DANE COUNTY DEPARTMENT of PUBLIC WORKS, HIGHWAY and TRANSPORTATION

RFB NO. 313086 - ADDENDUM NO. 5

ARCTIC ANIMAL EXHIBIT AND CONCESSIONS

This Addendum is issued to modify, explain or clarify the original Request for Bid (RFB) and is hereby made a part of the RFB. Please attach this Addendum to the RFB. **Bidders must acknowledge all Addenda on the Bid Form.**

1 SEAL HOLDING/LIFE SUPPORT FOUNDATION PLAN SCALE: 1/4"=1'-0"

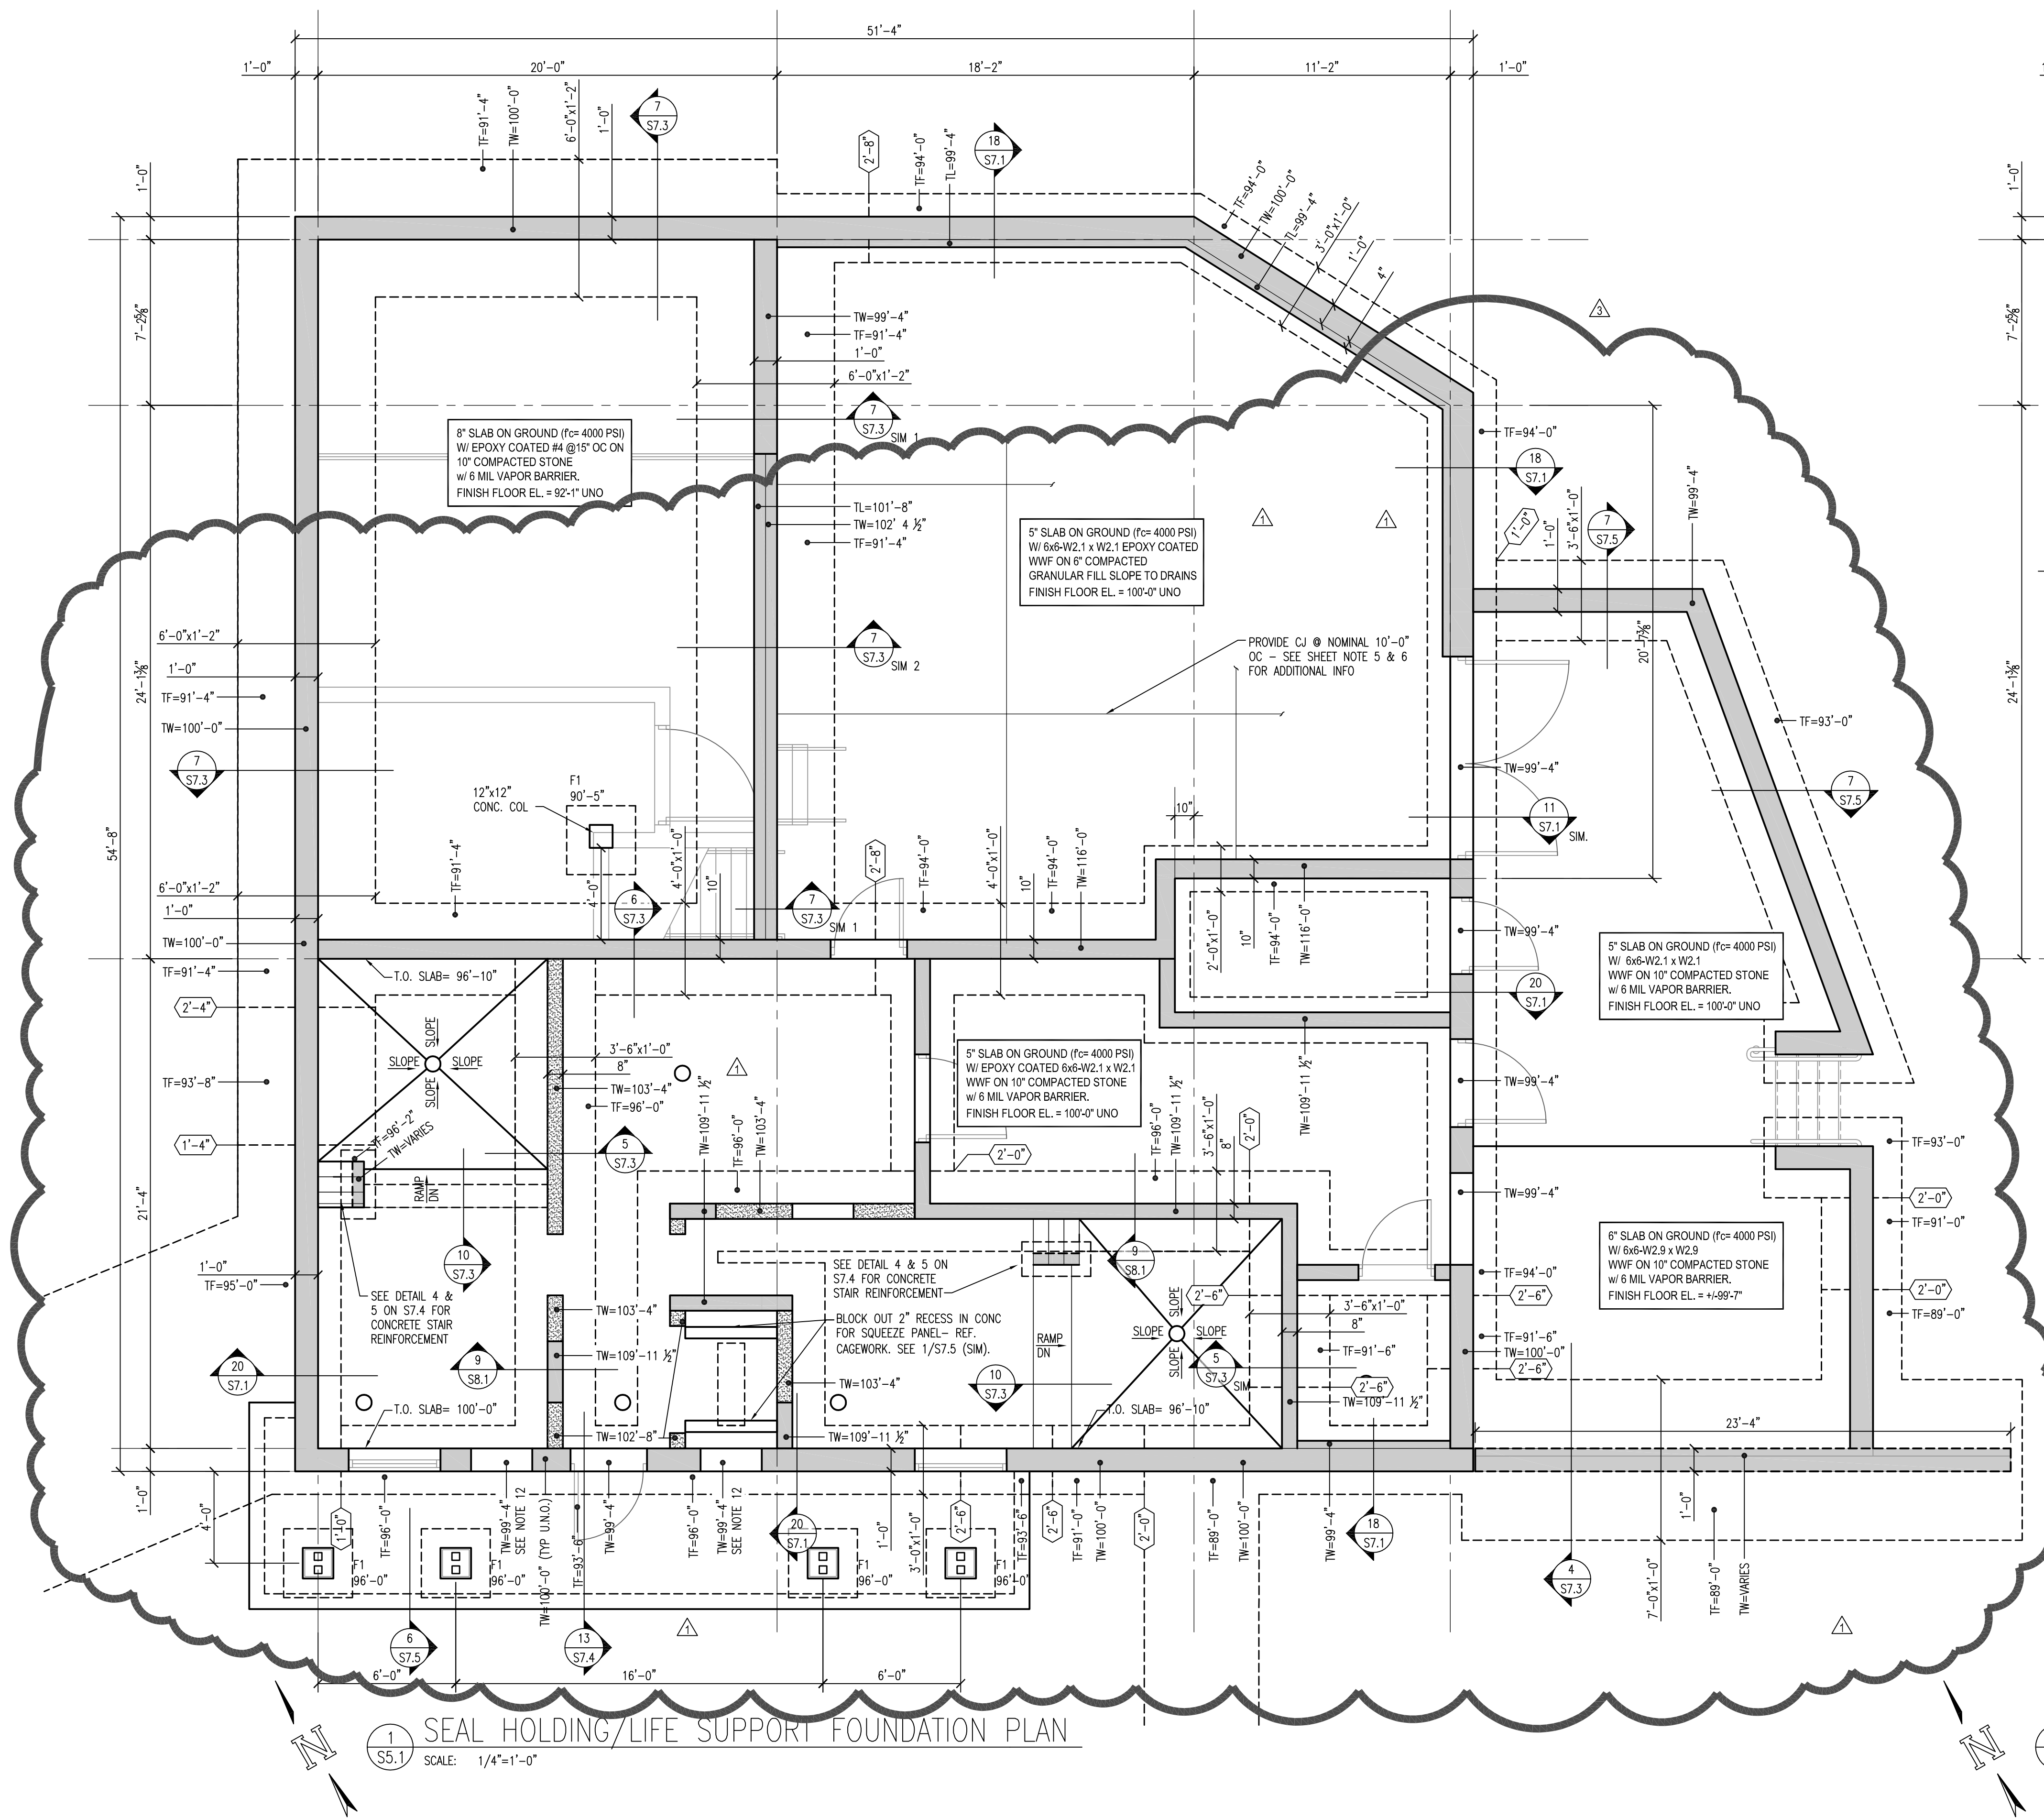
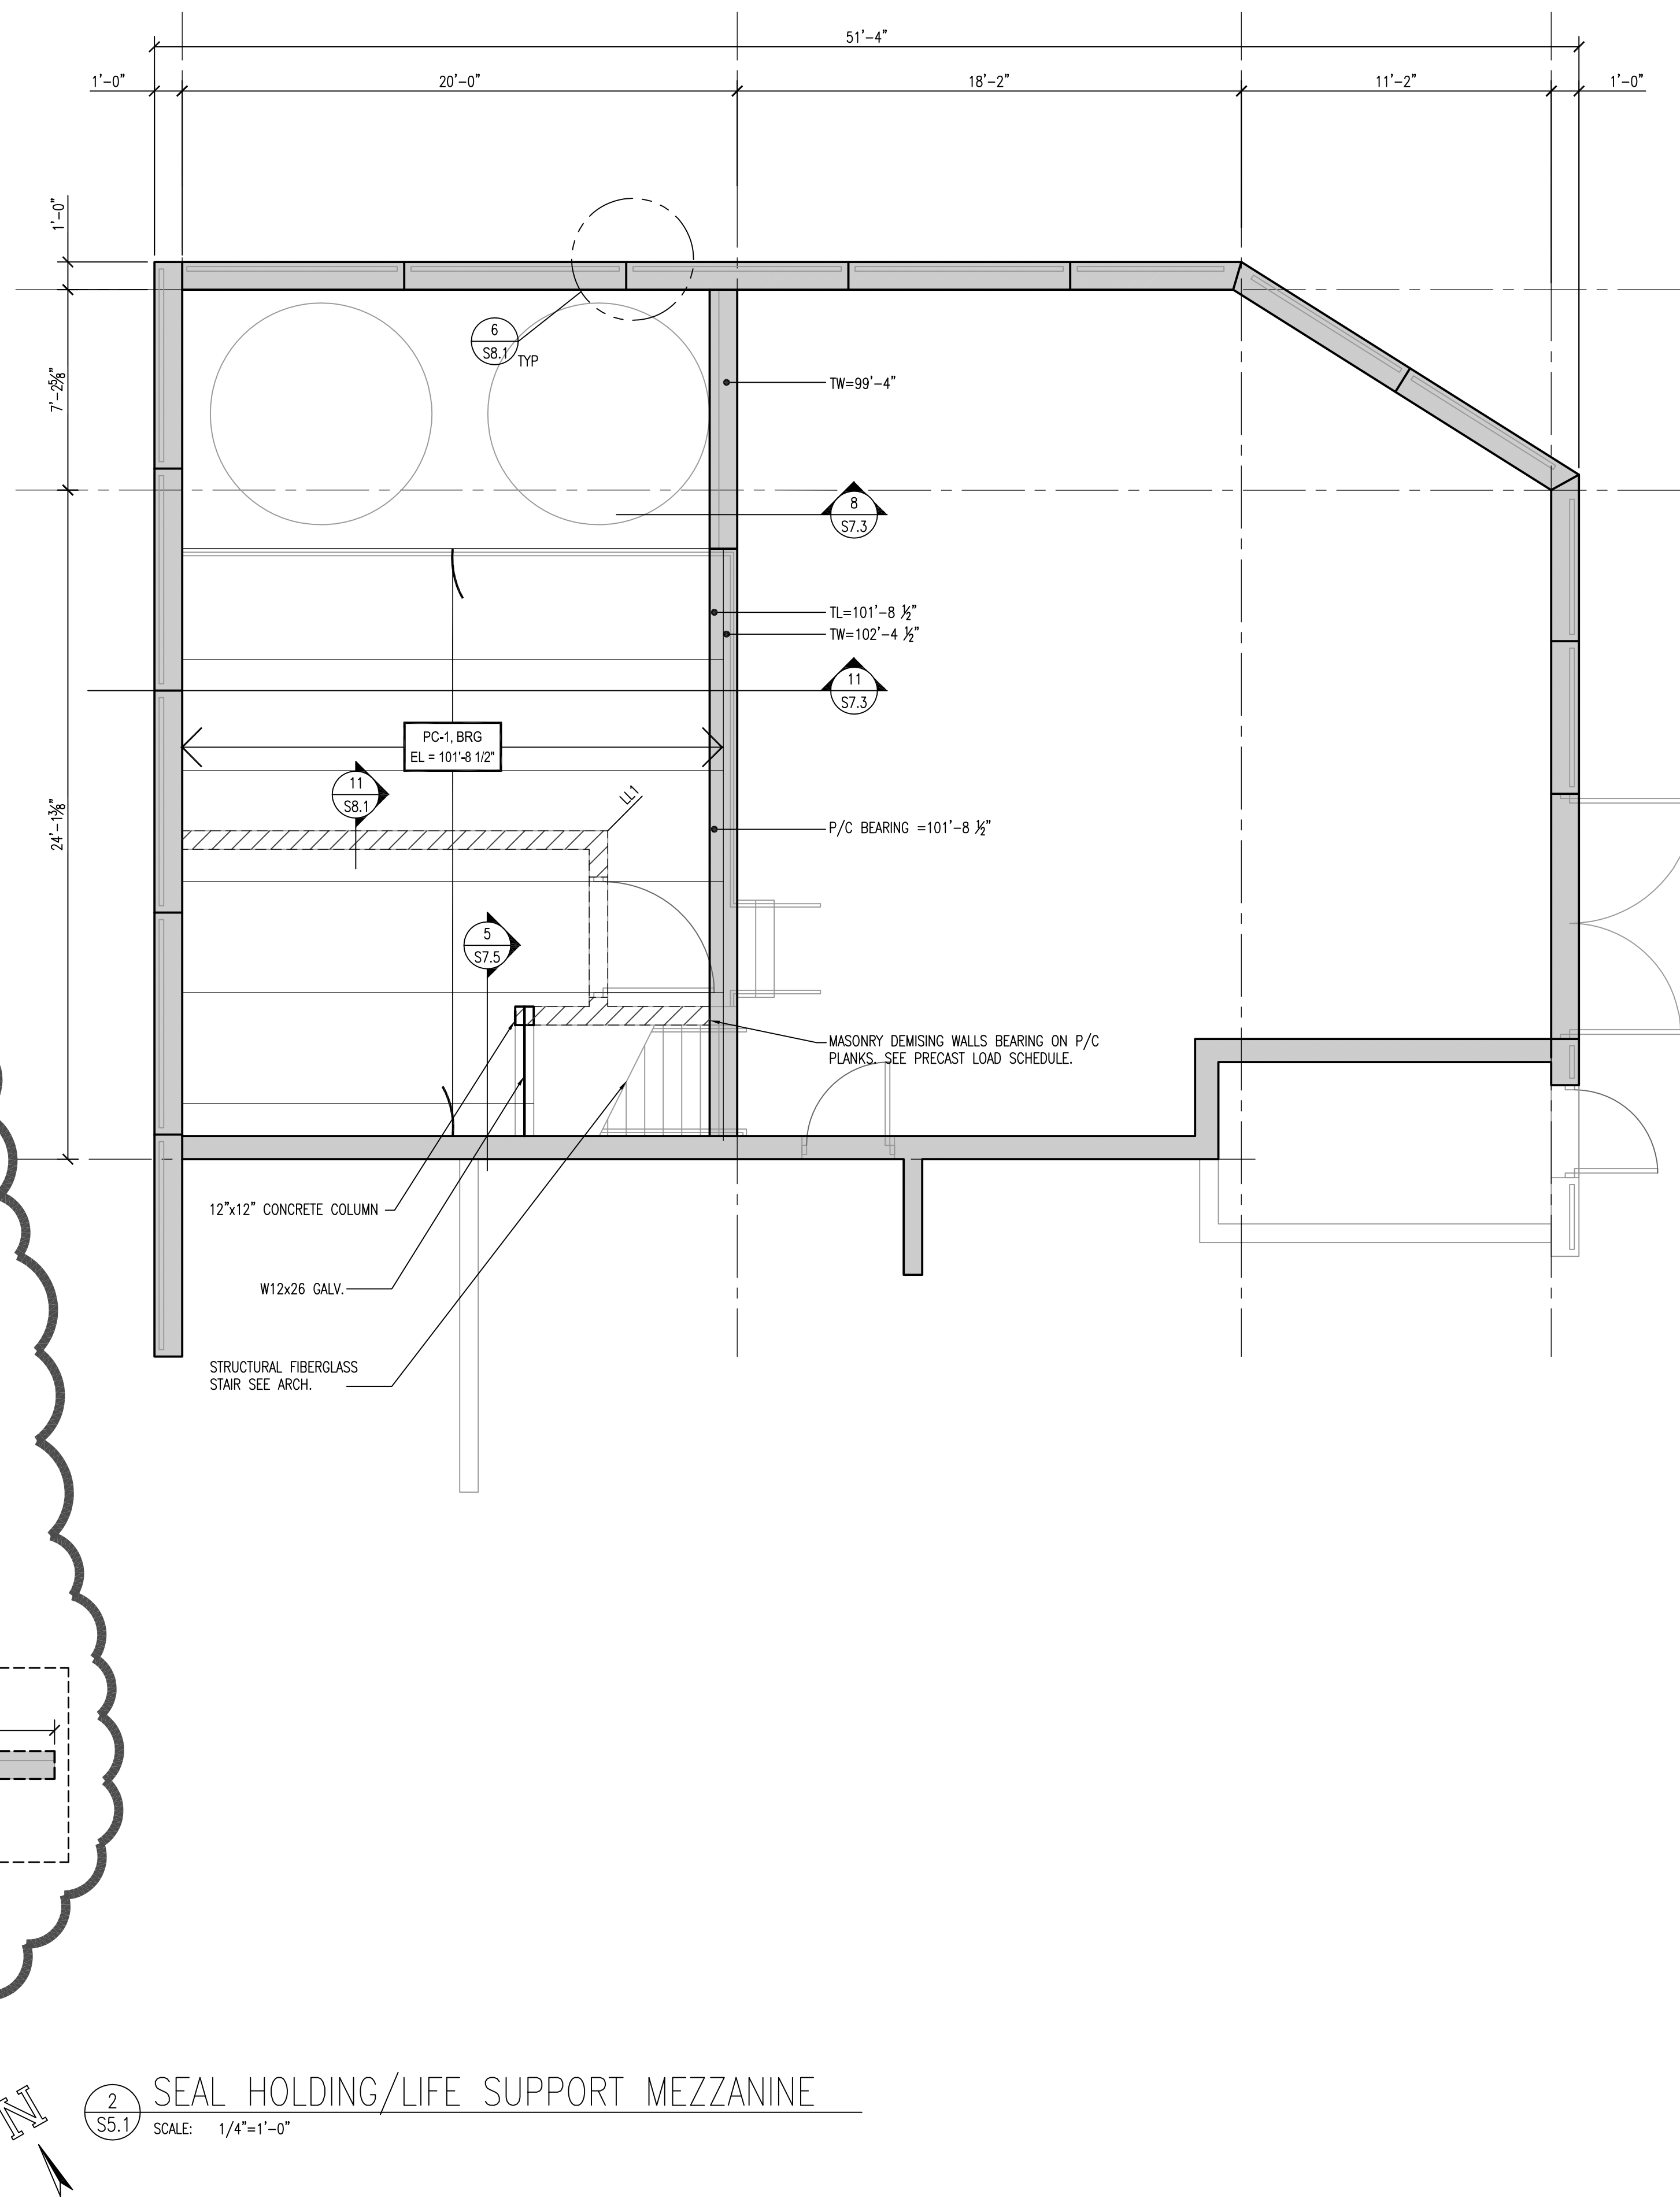
- Added Section 8/S9.2 and relocated 9/S9.2 in 2/S4.1
- 41. Sheet S5.1- Seal Holding/ Life Support Foundation Plan, Mezzanine Framing Plan**
 - Revised Footing Steps and elevations to account for future grade drop at SE corner

- Added 2" Recess for Squeeze Panel
 - Revised T.O. Wall near SW corner
- 42. S7.3 – Foundation Details**
 - Detail 13 – Revised T.O Wall
- 43. S7.5 – Foundation Details**

SR1.1

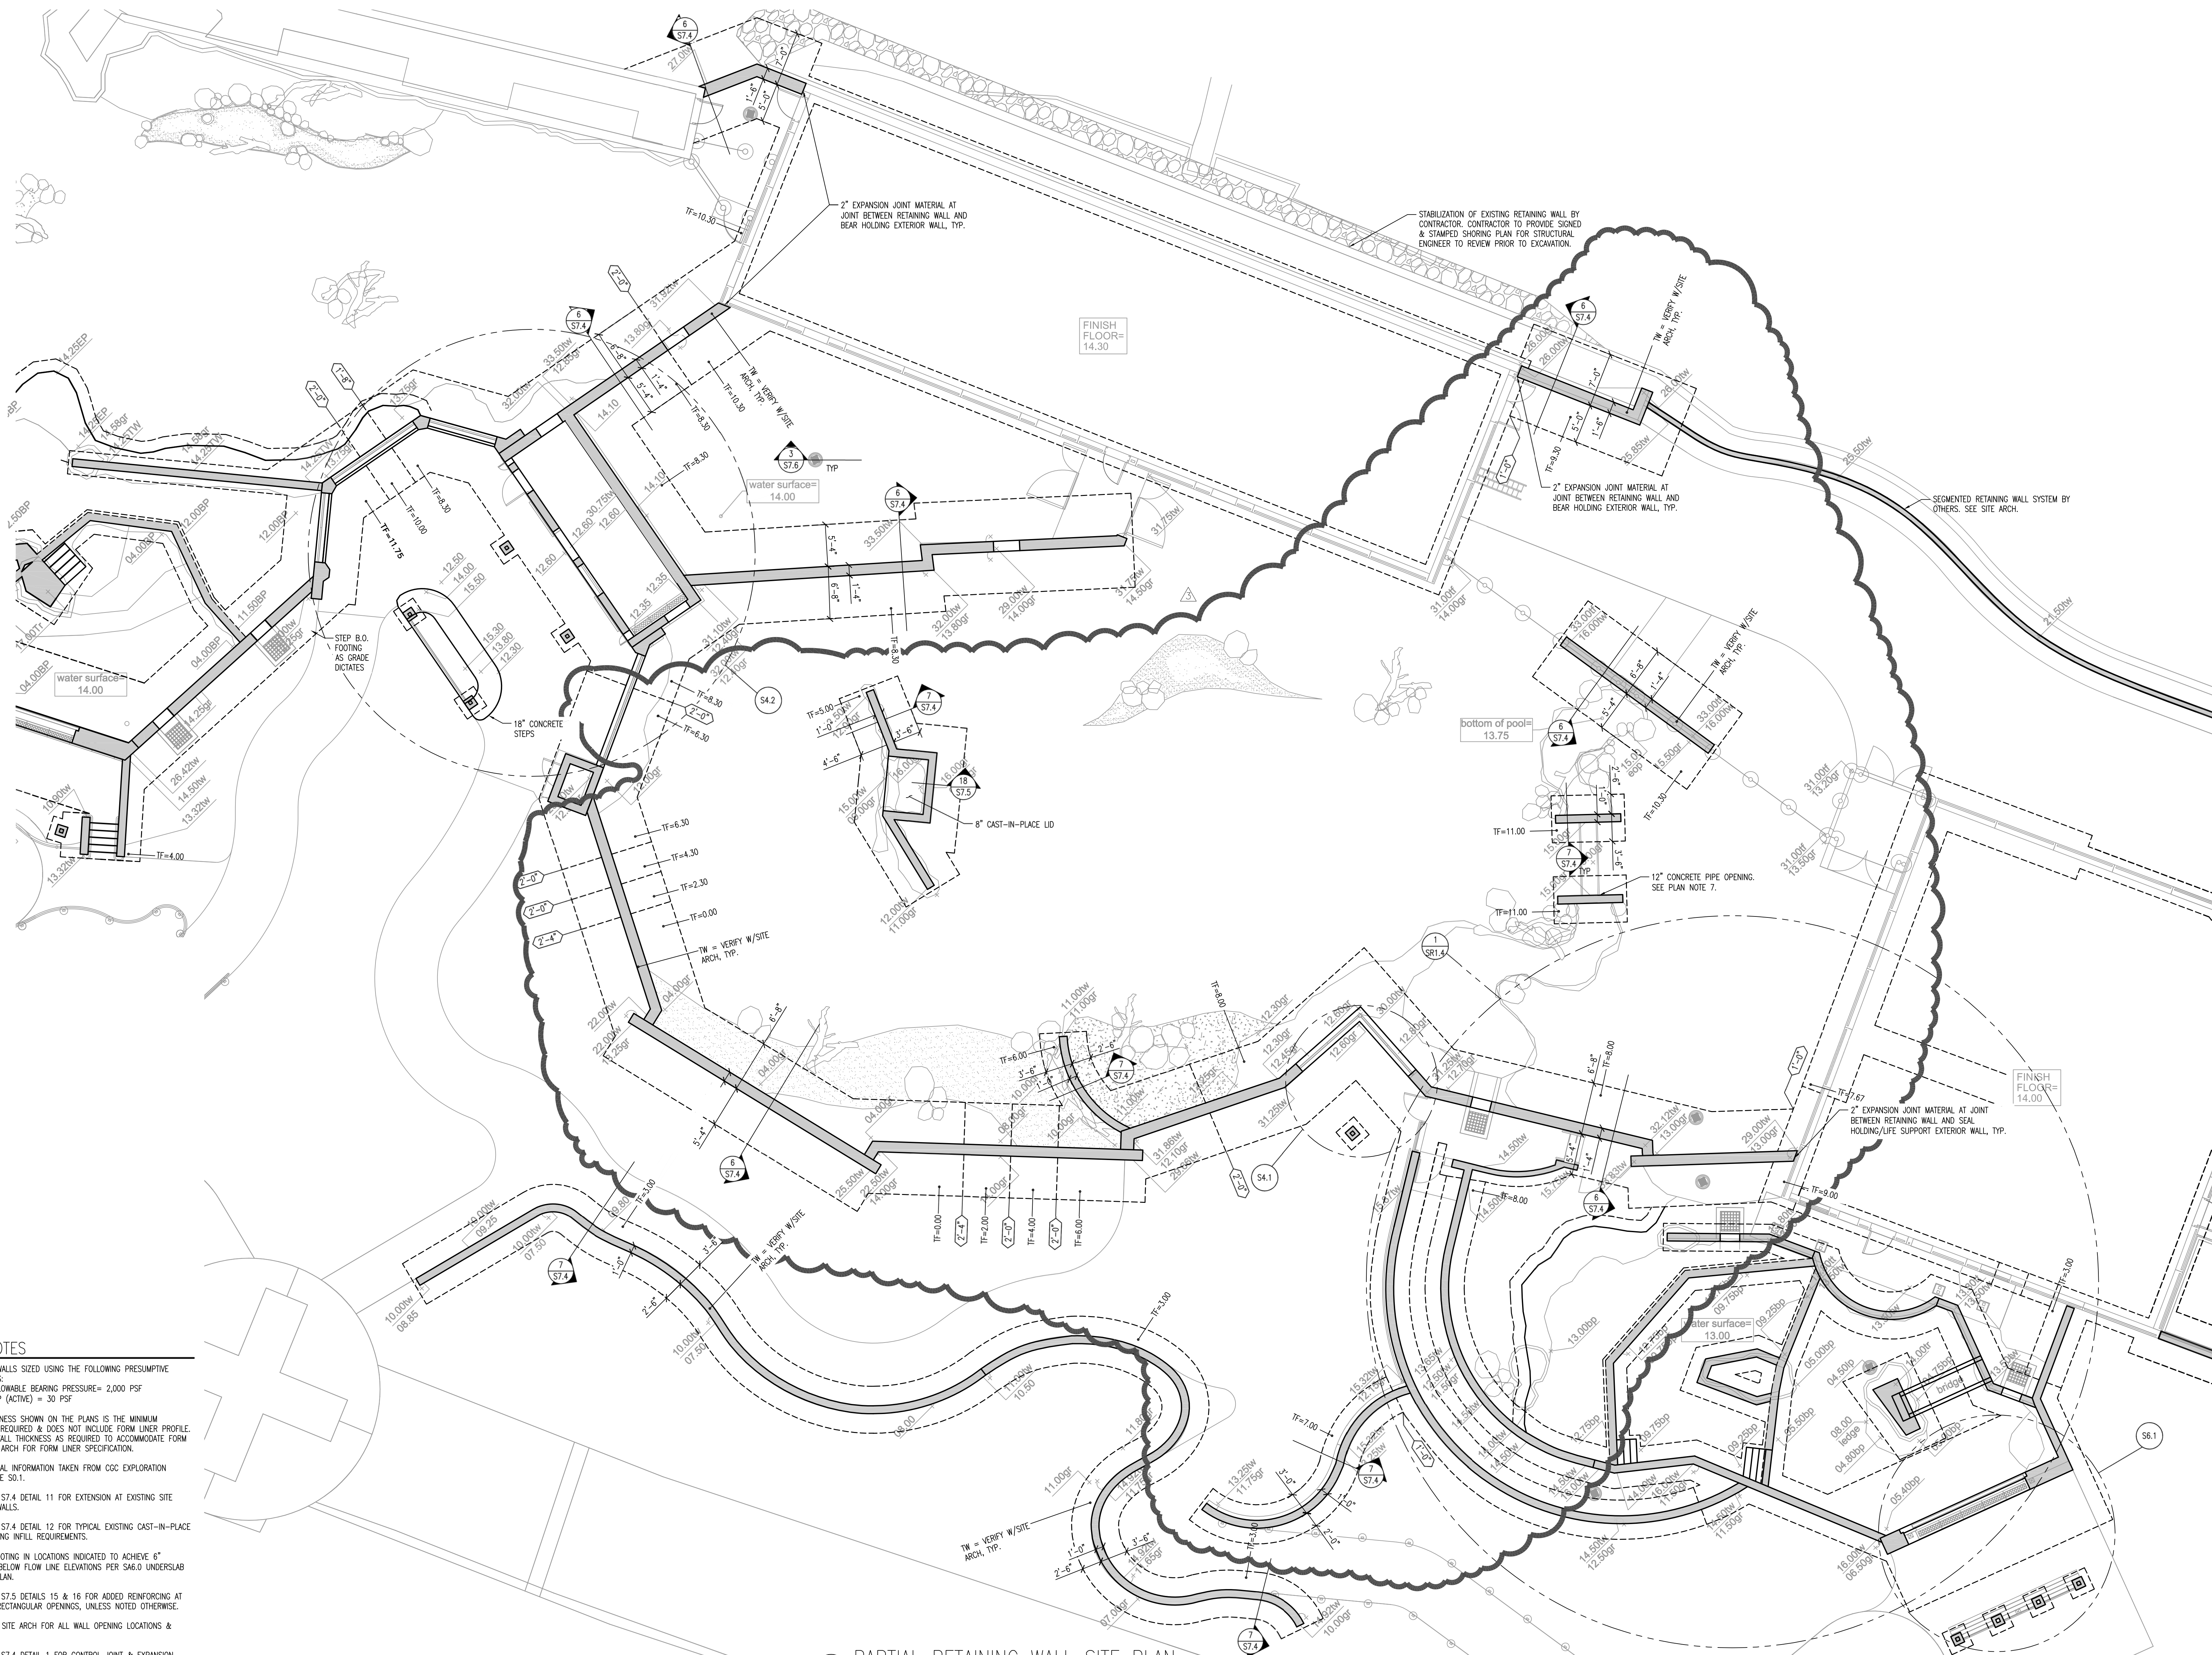
- 45. S9.2 – Steel Framing Details**
 - Added Detail 8 and Revised Detail 9
- 46. SR1.1 – Retaining Wall Partial Site Plan**
 - Revised T.O Footing and added footing steps in multiple locations to meet Geotech Report requirements.

- Added 'At footings that do not bear 5'-6", use...non-frost susceptible sub-base' note
- 47. SR1.2 – Retaining Wall Partial Site Plan**
 - Revised T.O Footing and added footing steps in multiple locations to meet Geotech Report requirements.
